**Before the Hearings Panel  
At Porirua City Council**

**In the matter of** the Proposed Porirua District Plan

**Statement of evidence of Dr Nicola Jane Litchfield on behalf of Porirua City  
Council**

**Date:** 20 October 2021

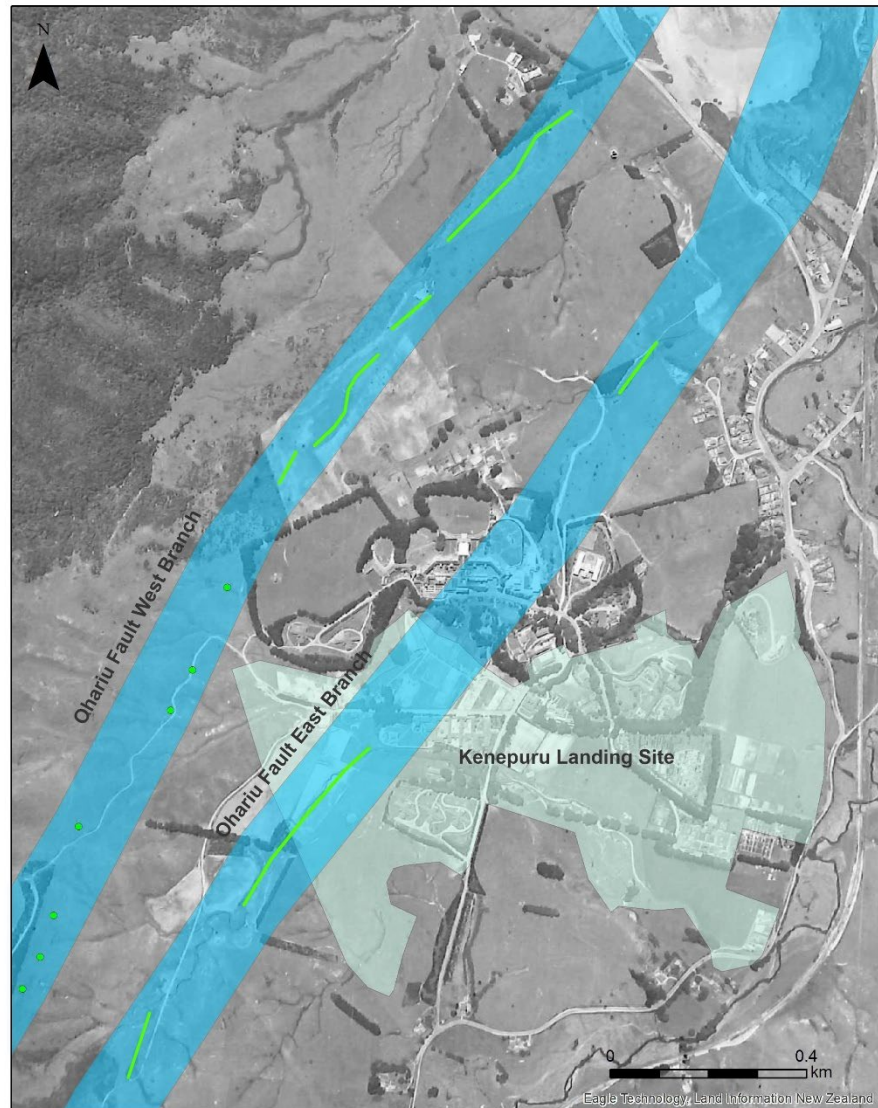
- 18.1 The east branch of the Ohariu Fault passes through the Kenepuru Landing Site, and the Fault Rupture Zone in the PDP is based upon the FAZ developed by Litchfield and Van Dissen (2014) and is 170 m wide (Figure 1)<sup>2</sup>.

- 18.2 I have reviewed the data used by Litchfield and Van Dissen (2014) to define the FAZ in the vicinity of the Kenepuru Landing Site. These data are shown in Figure 1 and are stream alignments on 1940s aerial photographs in the southwest part of the site (Mitchell Stream) and ~650 m northeast of the site. The location across the remainder of the Kenepuru Landing Site was considered uncertain in large part because of extensive ground surface modifications associated with the former Kenepuru Hospital.

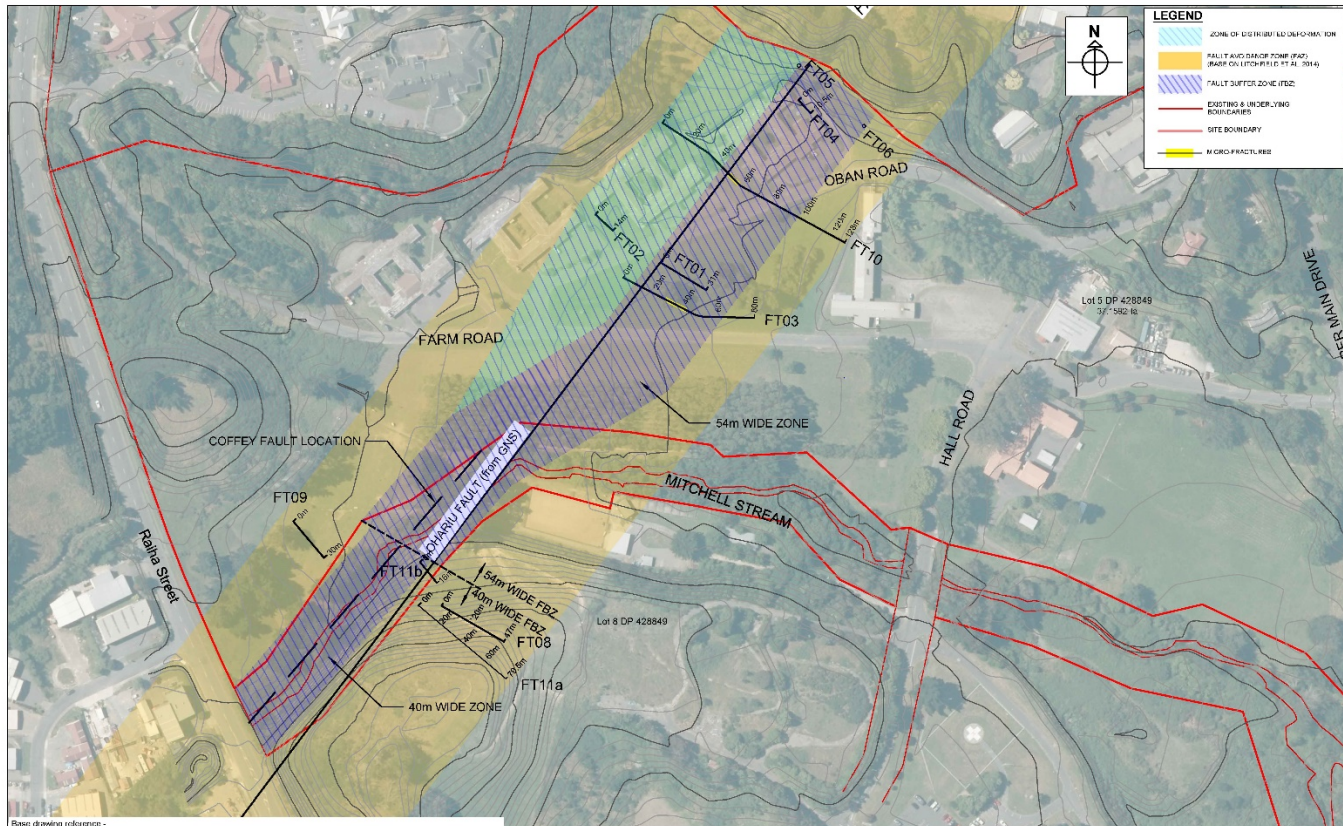
report by J Begg Geo (2020) supplied by Council. Coffey propose a Fault Buffer Zone that is 40 m wide in the south (Mitchell Stream) and 54 m wide in the centre and north (Figure 2). They have also proposed a Distributed Deformation Zone adjacent to the northern Buffer Zone.

19.1 The Coffey southern Fault Buffer Zone is defined by the current centreline of Mitchell Stream and a 20 m buffer either side. I consider this zone to be too narrow for several reasons:

1) Mitchell Stream in this area appears to have been modified (moved northwest) from the presumed natural location on the 1940s aerial photographs;

2) The centreline doesn't take into account the sinuosity of the stream and therefore the related uncertainty of the fault location;

3) The use of a centreline (rather than an uncertainty zone) implies that the Ohariu Fault is of 0 m width, contrary to the northern Fault Buffer Zone; and

4) it is my opinion that trenches FT09 and FT11b were too shallow, with a base in alluvium (FT09) and silt (FT11b) that could be younger than the most recent metre-scale surface rupturing earthquake on the Ohariu Fault (1050-1000 years ago; Litchfield et al. 2004, 2006, 2010). Therefore, I consider the presence of the Ohariu Fault below the base of these trenches cannot be ruled out.

- 19.2 The Coffey northern Fault Buffer Zone is defined by a 14 m wide zone of concentrated micro-fractures found in several trenches and a 20 m buffer either side. It also incorporates two of three geophysical anomalies (A and B) identified in a separate study.
- 19.3 While I concur that the micro-fractures could represent distributed deformation of the Ohariu Fault at depth, in my opinion, like the trenches in the south, the northern trenches were too shallow, and the base of FT03 and FT10 in particular were within alluvium that could be younger than the most recent surface rupturing earthquake on the Ohariu Fault. Therefore, I consider the presence of the Ohariu Fault below the base of these trenches and beyond the proposed Fault Buffer Zone cannot be ruled out.

- 19.4 In the centre of the Kenepuru Landing Site, the Fault Buffer Zone is not constrained by trench evidence. The northern Fault Buffer Zone has been extended southward at the same width (54 m) to a point where Mitchell Stream deflects to the northeast, where the Fault Buffer Zones abruptly narrows to 40 m width. This implies that the Ohariu Fault undergoes a step and an abrupt change in width but no evidence is presented for either.
- 19.5 I consider it unlikely that the Ohariu Fault undergoes these changes because they are too abrupt and there is no evidence for them, therefore a tapering zone between the northern and southern areas is equally as likely.

- 19.6 The Distributed Zone is based upon there being a “risk of distributed ground deformation, due to a ‘kink’ in the buffer zone/fault” (Coffey 2021 page 2). This zone also includes a set of micro-fractures in FT10 and geophysical anomaly C.
- 19.7 While the presence of this zone is possible, it is unclear to me why such a kink would produce a Distributed Zone only on one side of a strike-slip fault. That is, if the Distributed Zone is the result of compression on the northwest side of the northern Fault Buffer Zone, why is there no equivalent Distributed Zone adjacent to the southeast side of the southern Fault Buffer Zone?
- 20 Based upon the above analysis of the Coffey reports, I do not agree with the location and definition of the Fault Buffer/Distributed Zones included in the Coffey reports and referred to in Submission 59.

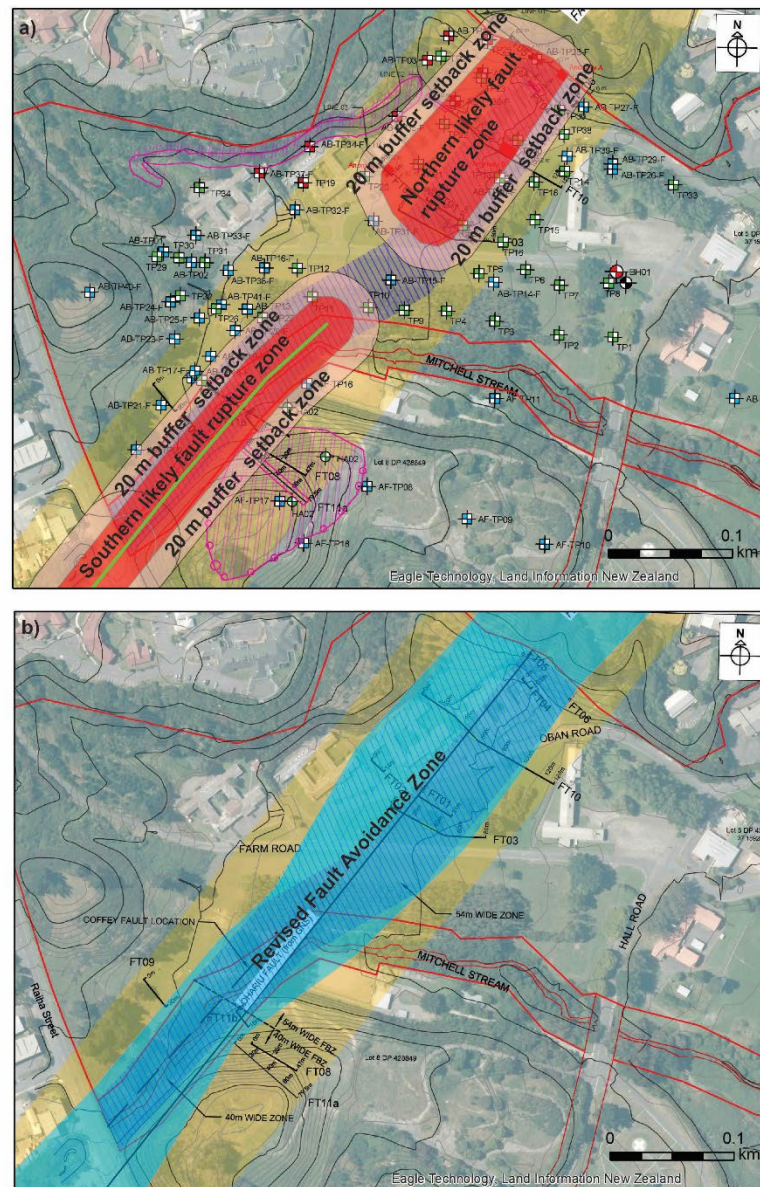
- 21 In my opinion the eastern Ohariu Fault FAZ through the Kenepuru Landing Site could be revised as identified in Figure 3<sup>3</sup>. The revision uses the methodology<sup>4</sup> and some data from Litchfield and Van Dissen

- 21.1 In the south a likely fault rupture zone (red) is constructed from a buffer either side of the Mitchell Stream trace mapped by Litchfield and Van Dissen (2014) from the 1940s aerial photographs (green line). The buffer is 22.25 m wide (noting that this may change slightly if the Coffey survey/GIS data could be obtained) constrained by the western end of FT11a (Figure 3a), which was entirely in bedrock and did not show any clear evidence of recent faulting. In the absence of any other information the same width is used on the west side of the fault. A 20 m buffer setback zone (pink) is then added either side, but this is modified on the east side to again meet the western end of FT11a. Thus, the total revised FAZ width would be 64.5–84.5 m, which is wider than, but does encompass, the Coffey Fault Buffer Zone (Figure 3b). It is narrower than the 170 m wide zone in the PDP.

- 21.2 In the north, a likely fault rupture zone (red) is constructed that is bound by the outer edges of (from top right to top left): geophysical anomaly A, geophysical anomaly B, the outer edge of the total zone of microfractures in FT03, geophysical anomaly C, and a step in bedrock in FT10. This step has not been identified as a fault, and could be a terrace riser, but the trench was not deep enough to rule it out as a fault scarp. The final (northernmost) point is projected along the same orientation. A 20 m buffer setback zone (pink) is then added either side. The total width of this revised FAZ is 101–119 m, similar to, but slightly wider than, the combined Coffey Fault Buffer and Distributed Zones (Figure 3b), but narrower than the 170 m wide zone in the PDP.

- 21.3 Between the two areas, the revised FAZ is joined with straight lines, and is also tapered to the existing FAZ

Figure 4. LiDAR map showing the features (green lines and yellow dots) used by Litchfield and Van Dissen (2014) to define the location of the Moonshine Fault FAZ (blue outline) crossing the proposed Future Urban Zone (white) at Judgeford Flats.

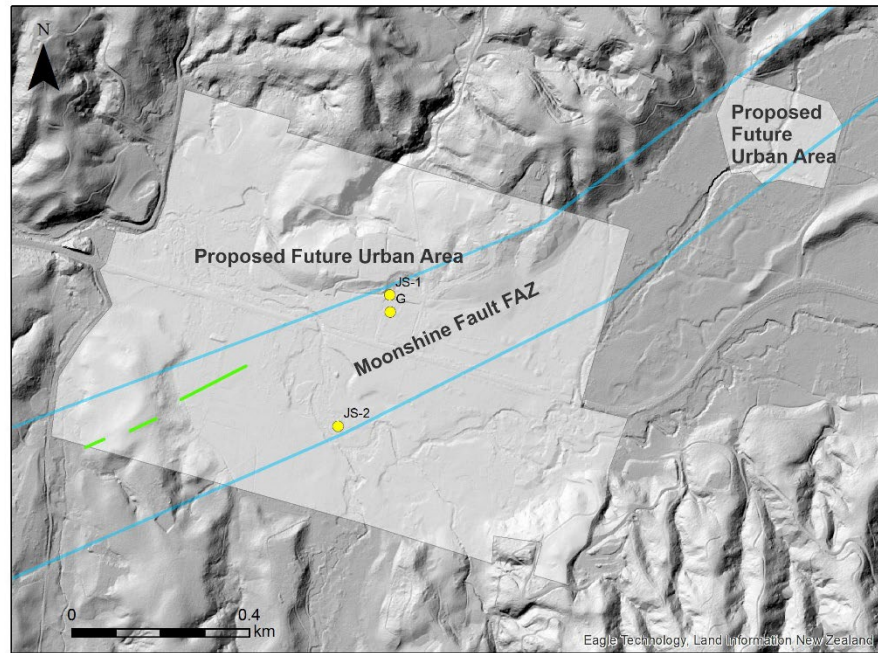
is at Judgeford Flats. The location of the Moonshine Fault at Judgeford Flats is inferred from a faint topographic step feature on Light Detecting and Ranging (**LiDAR**) data that is interpreted as a fault scarp (Litchfield and Van Dissen, 2014) and three drillholes that document a step in the greywacke basement surface inferred to be the result of movement on the Moonshine Fault (Begg, 1994) (Figure 4).

26.4 These data, along with the local topography, were used by Litchfield and Van Dissen (2014) to define the FAZ, which runs through the proposed Future Urban Zone (Figure 4).

26.5 It may be possible to further refine the location of the Moonshine Fault at Judgeford Flats using detailed fault mapping, geophysical or paleoseismological studies. This may reduce the width of the FAZ, but it is unlikely to remove it from crossing the proposed Future Urban Zone.
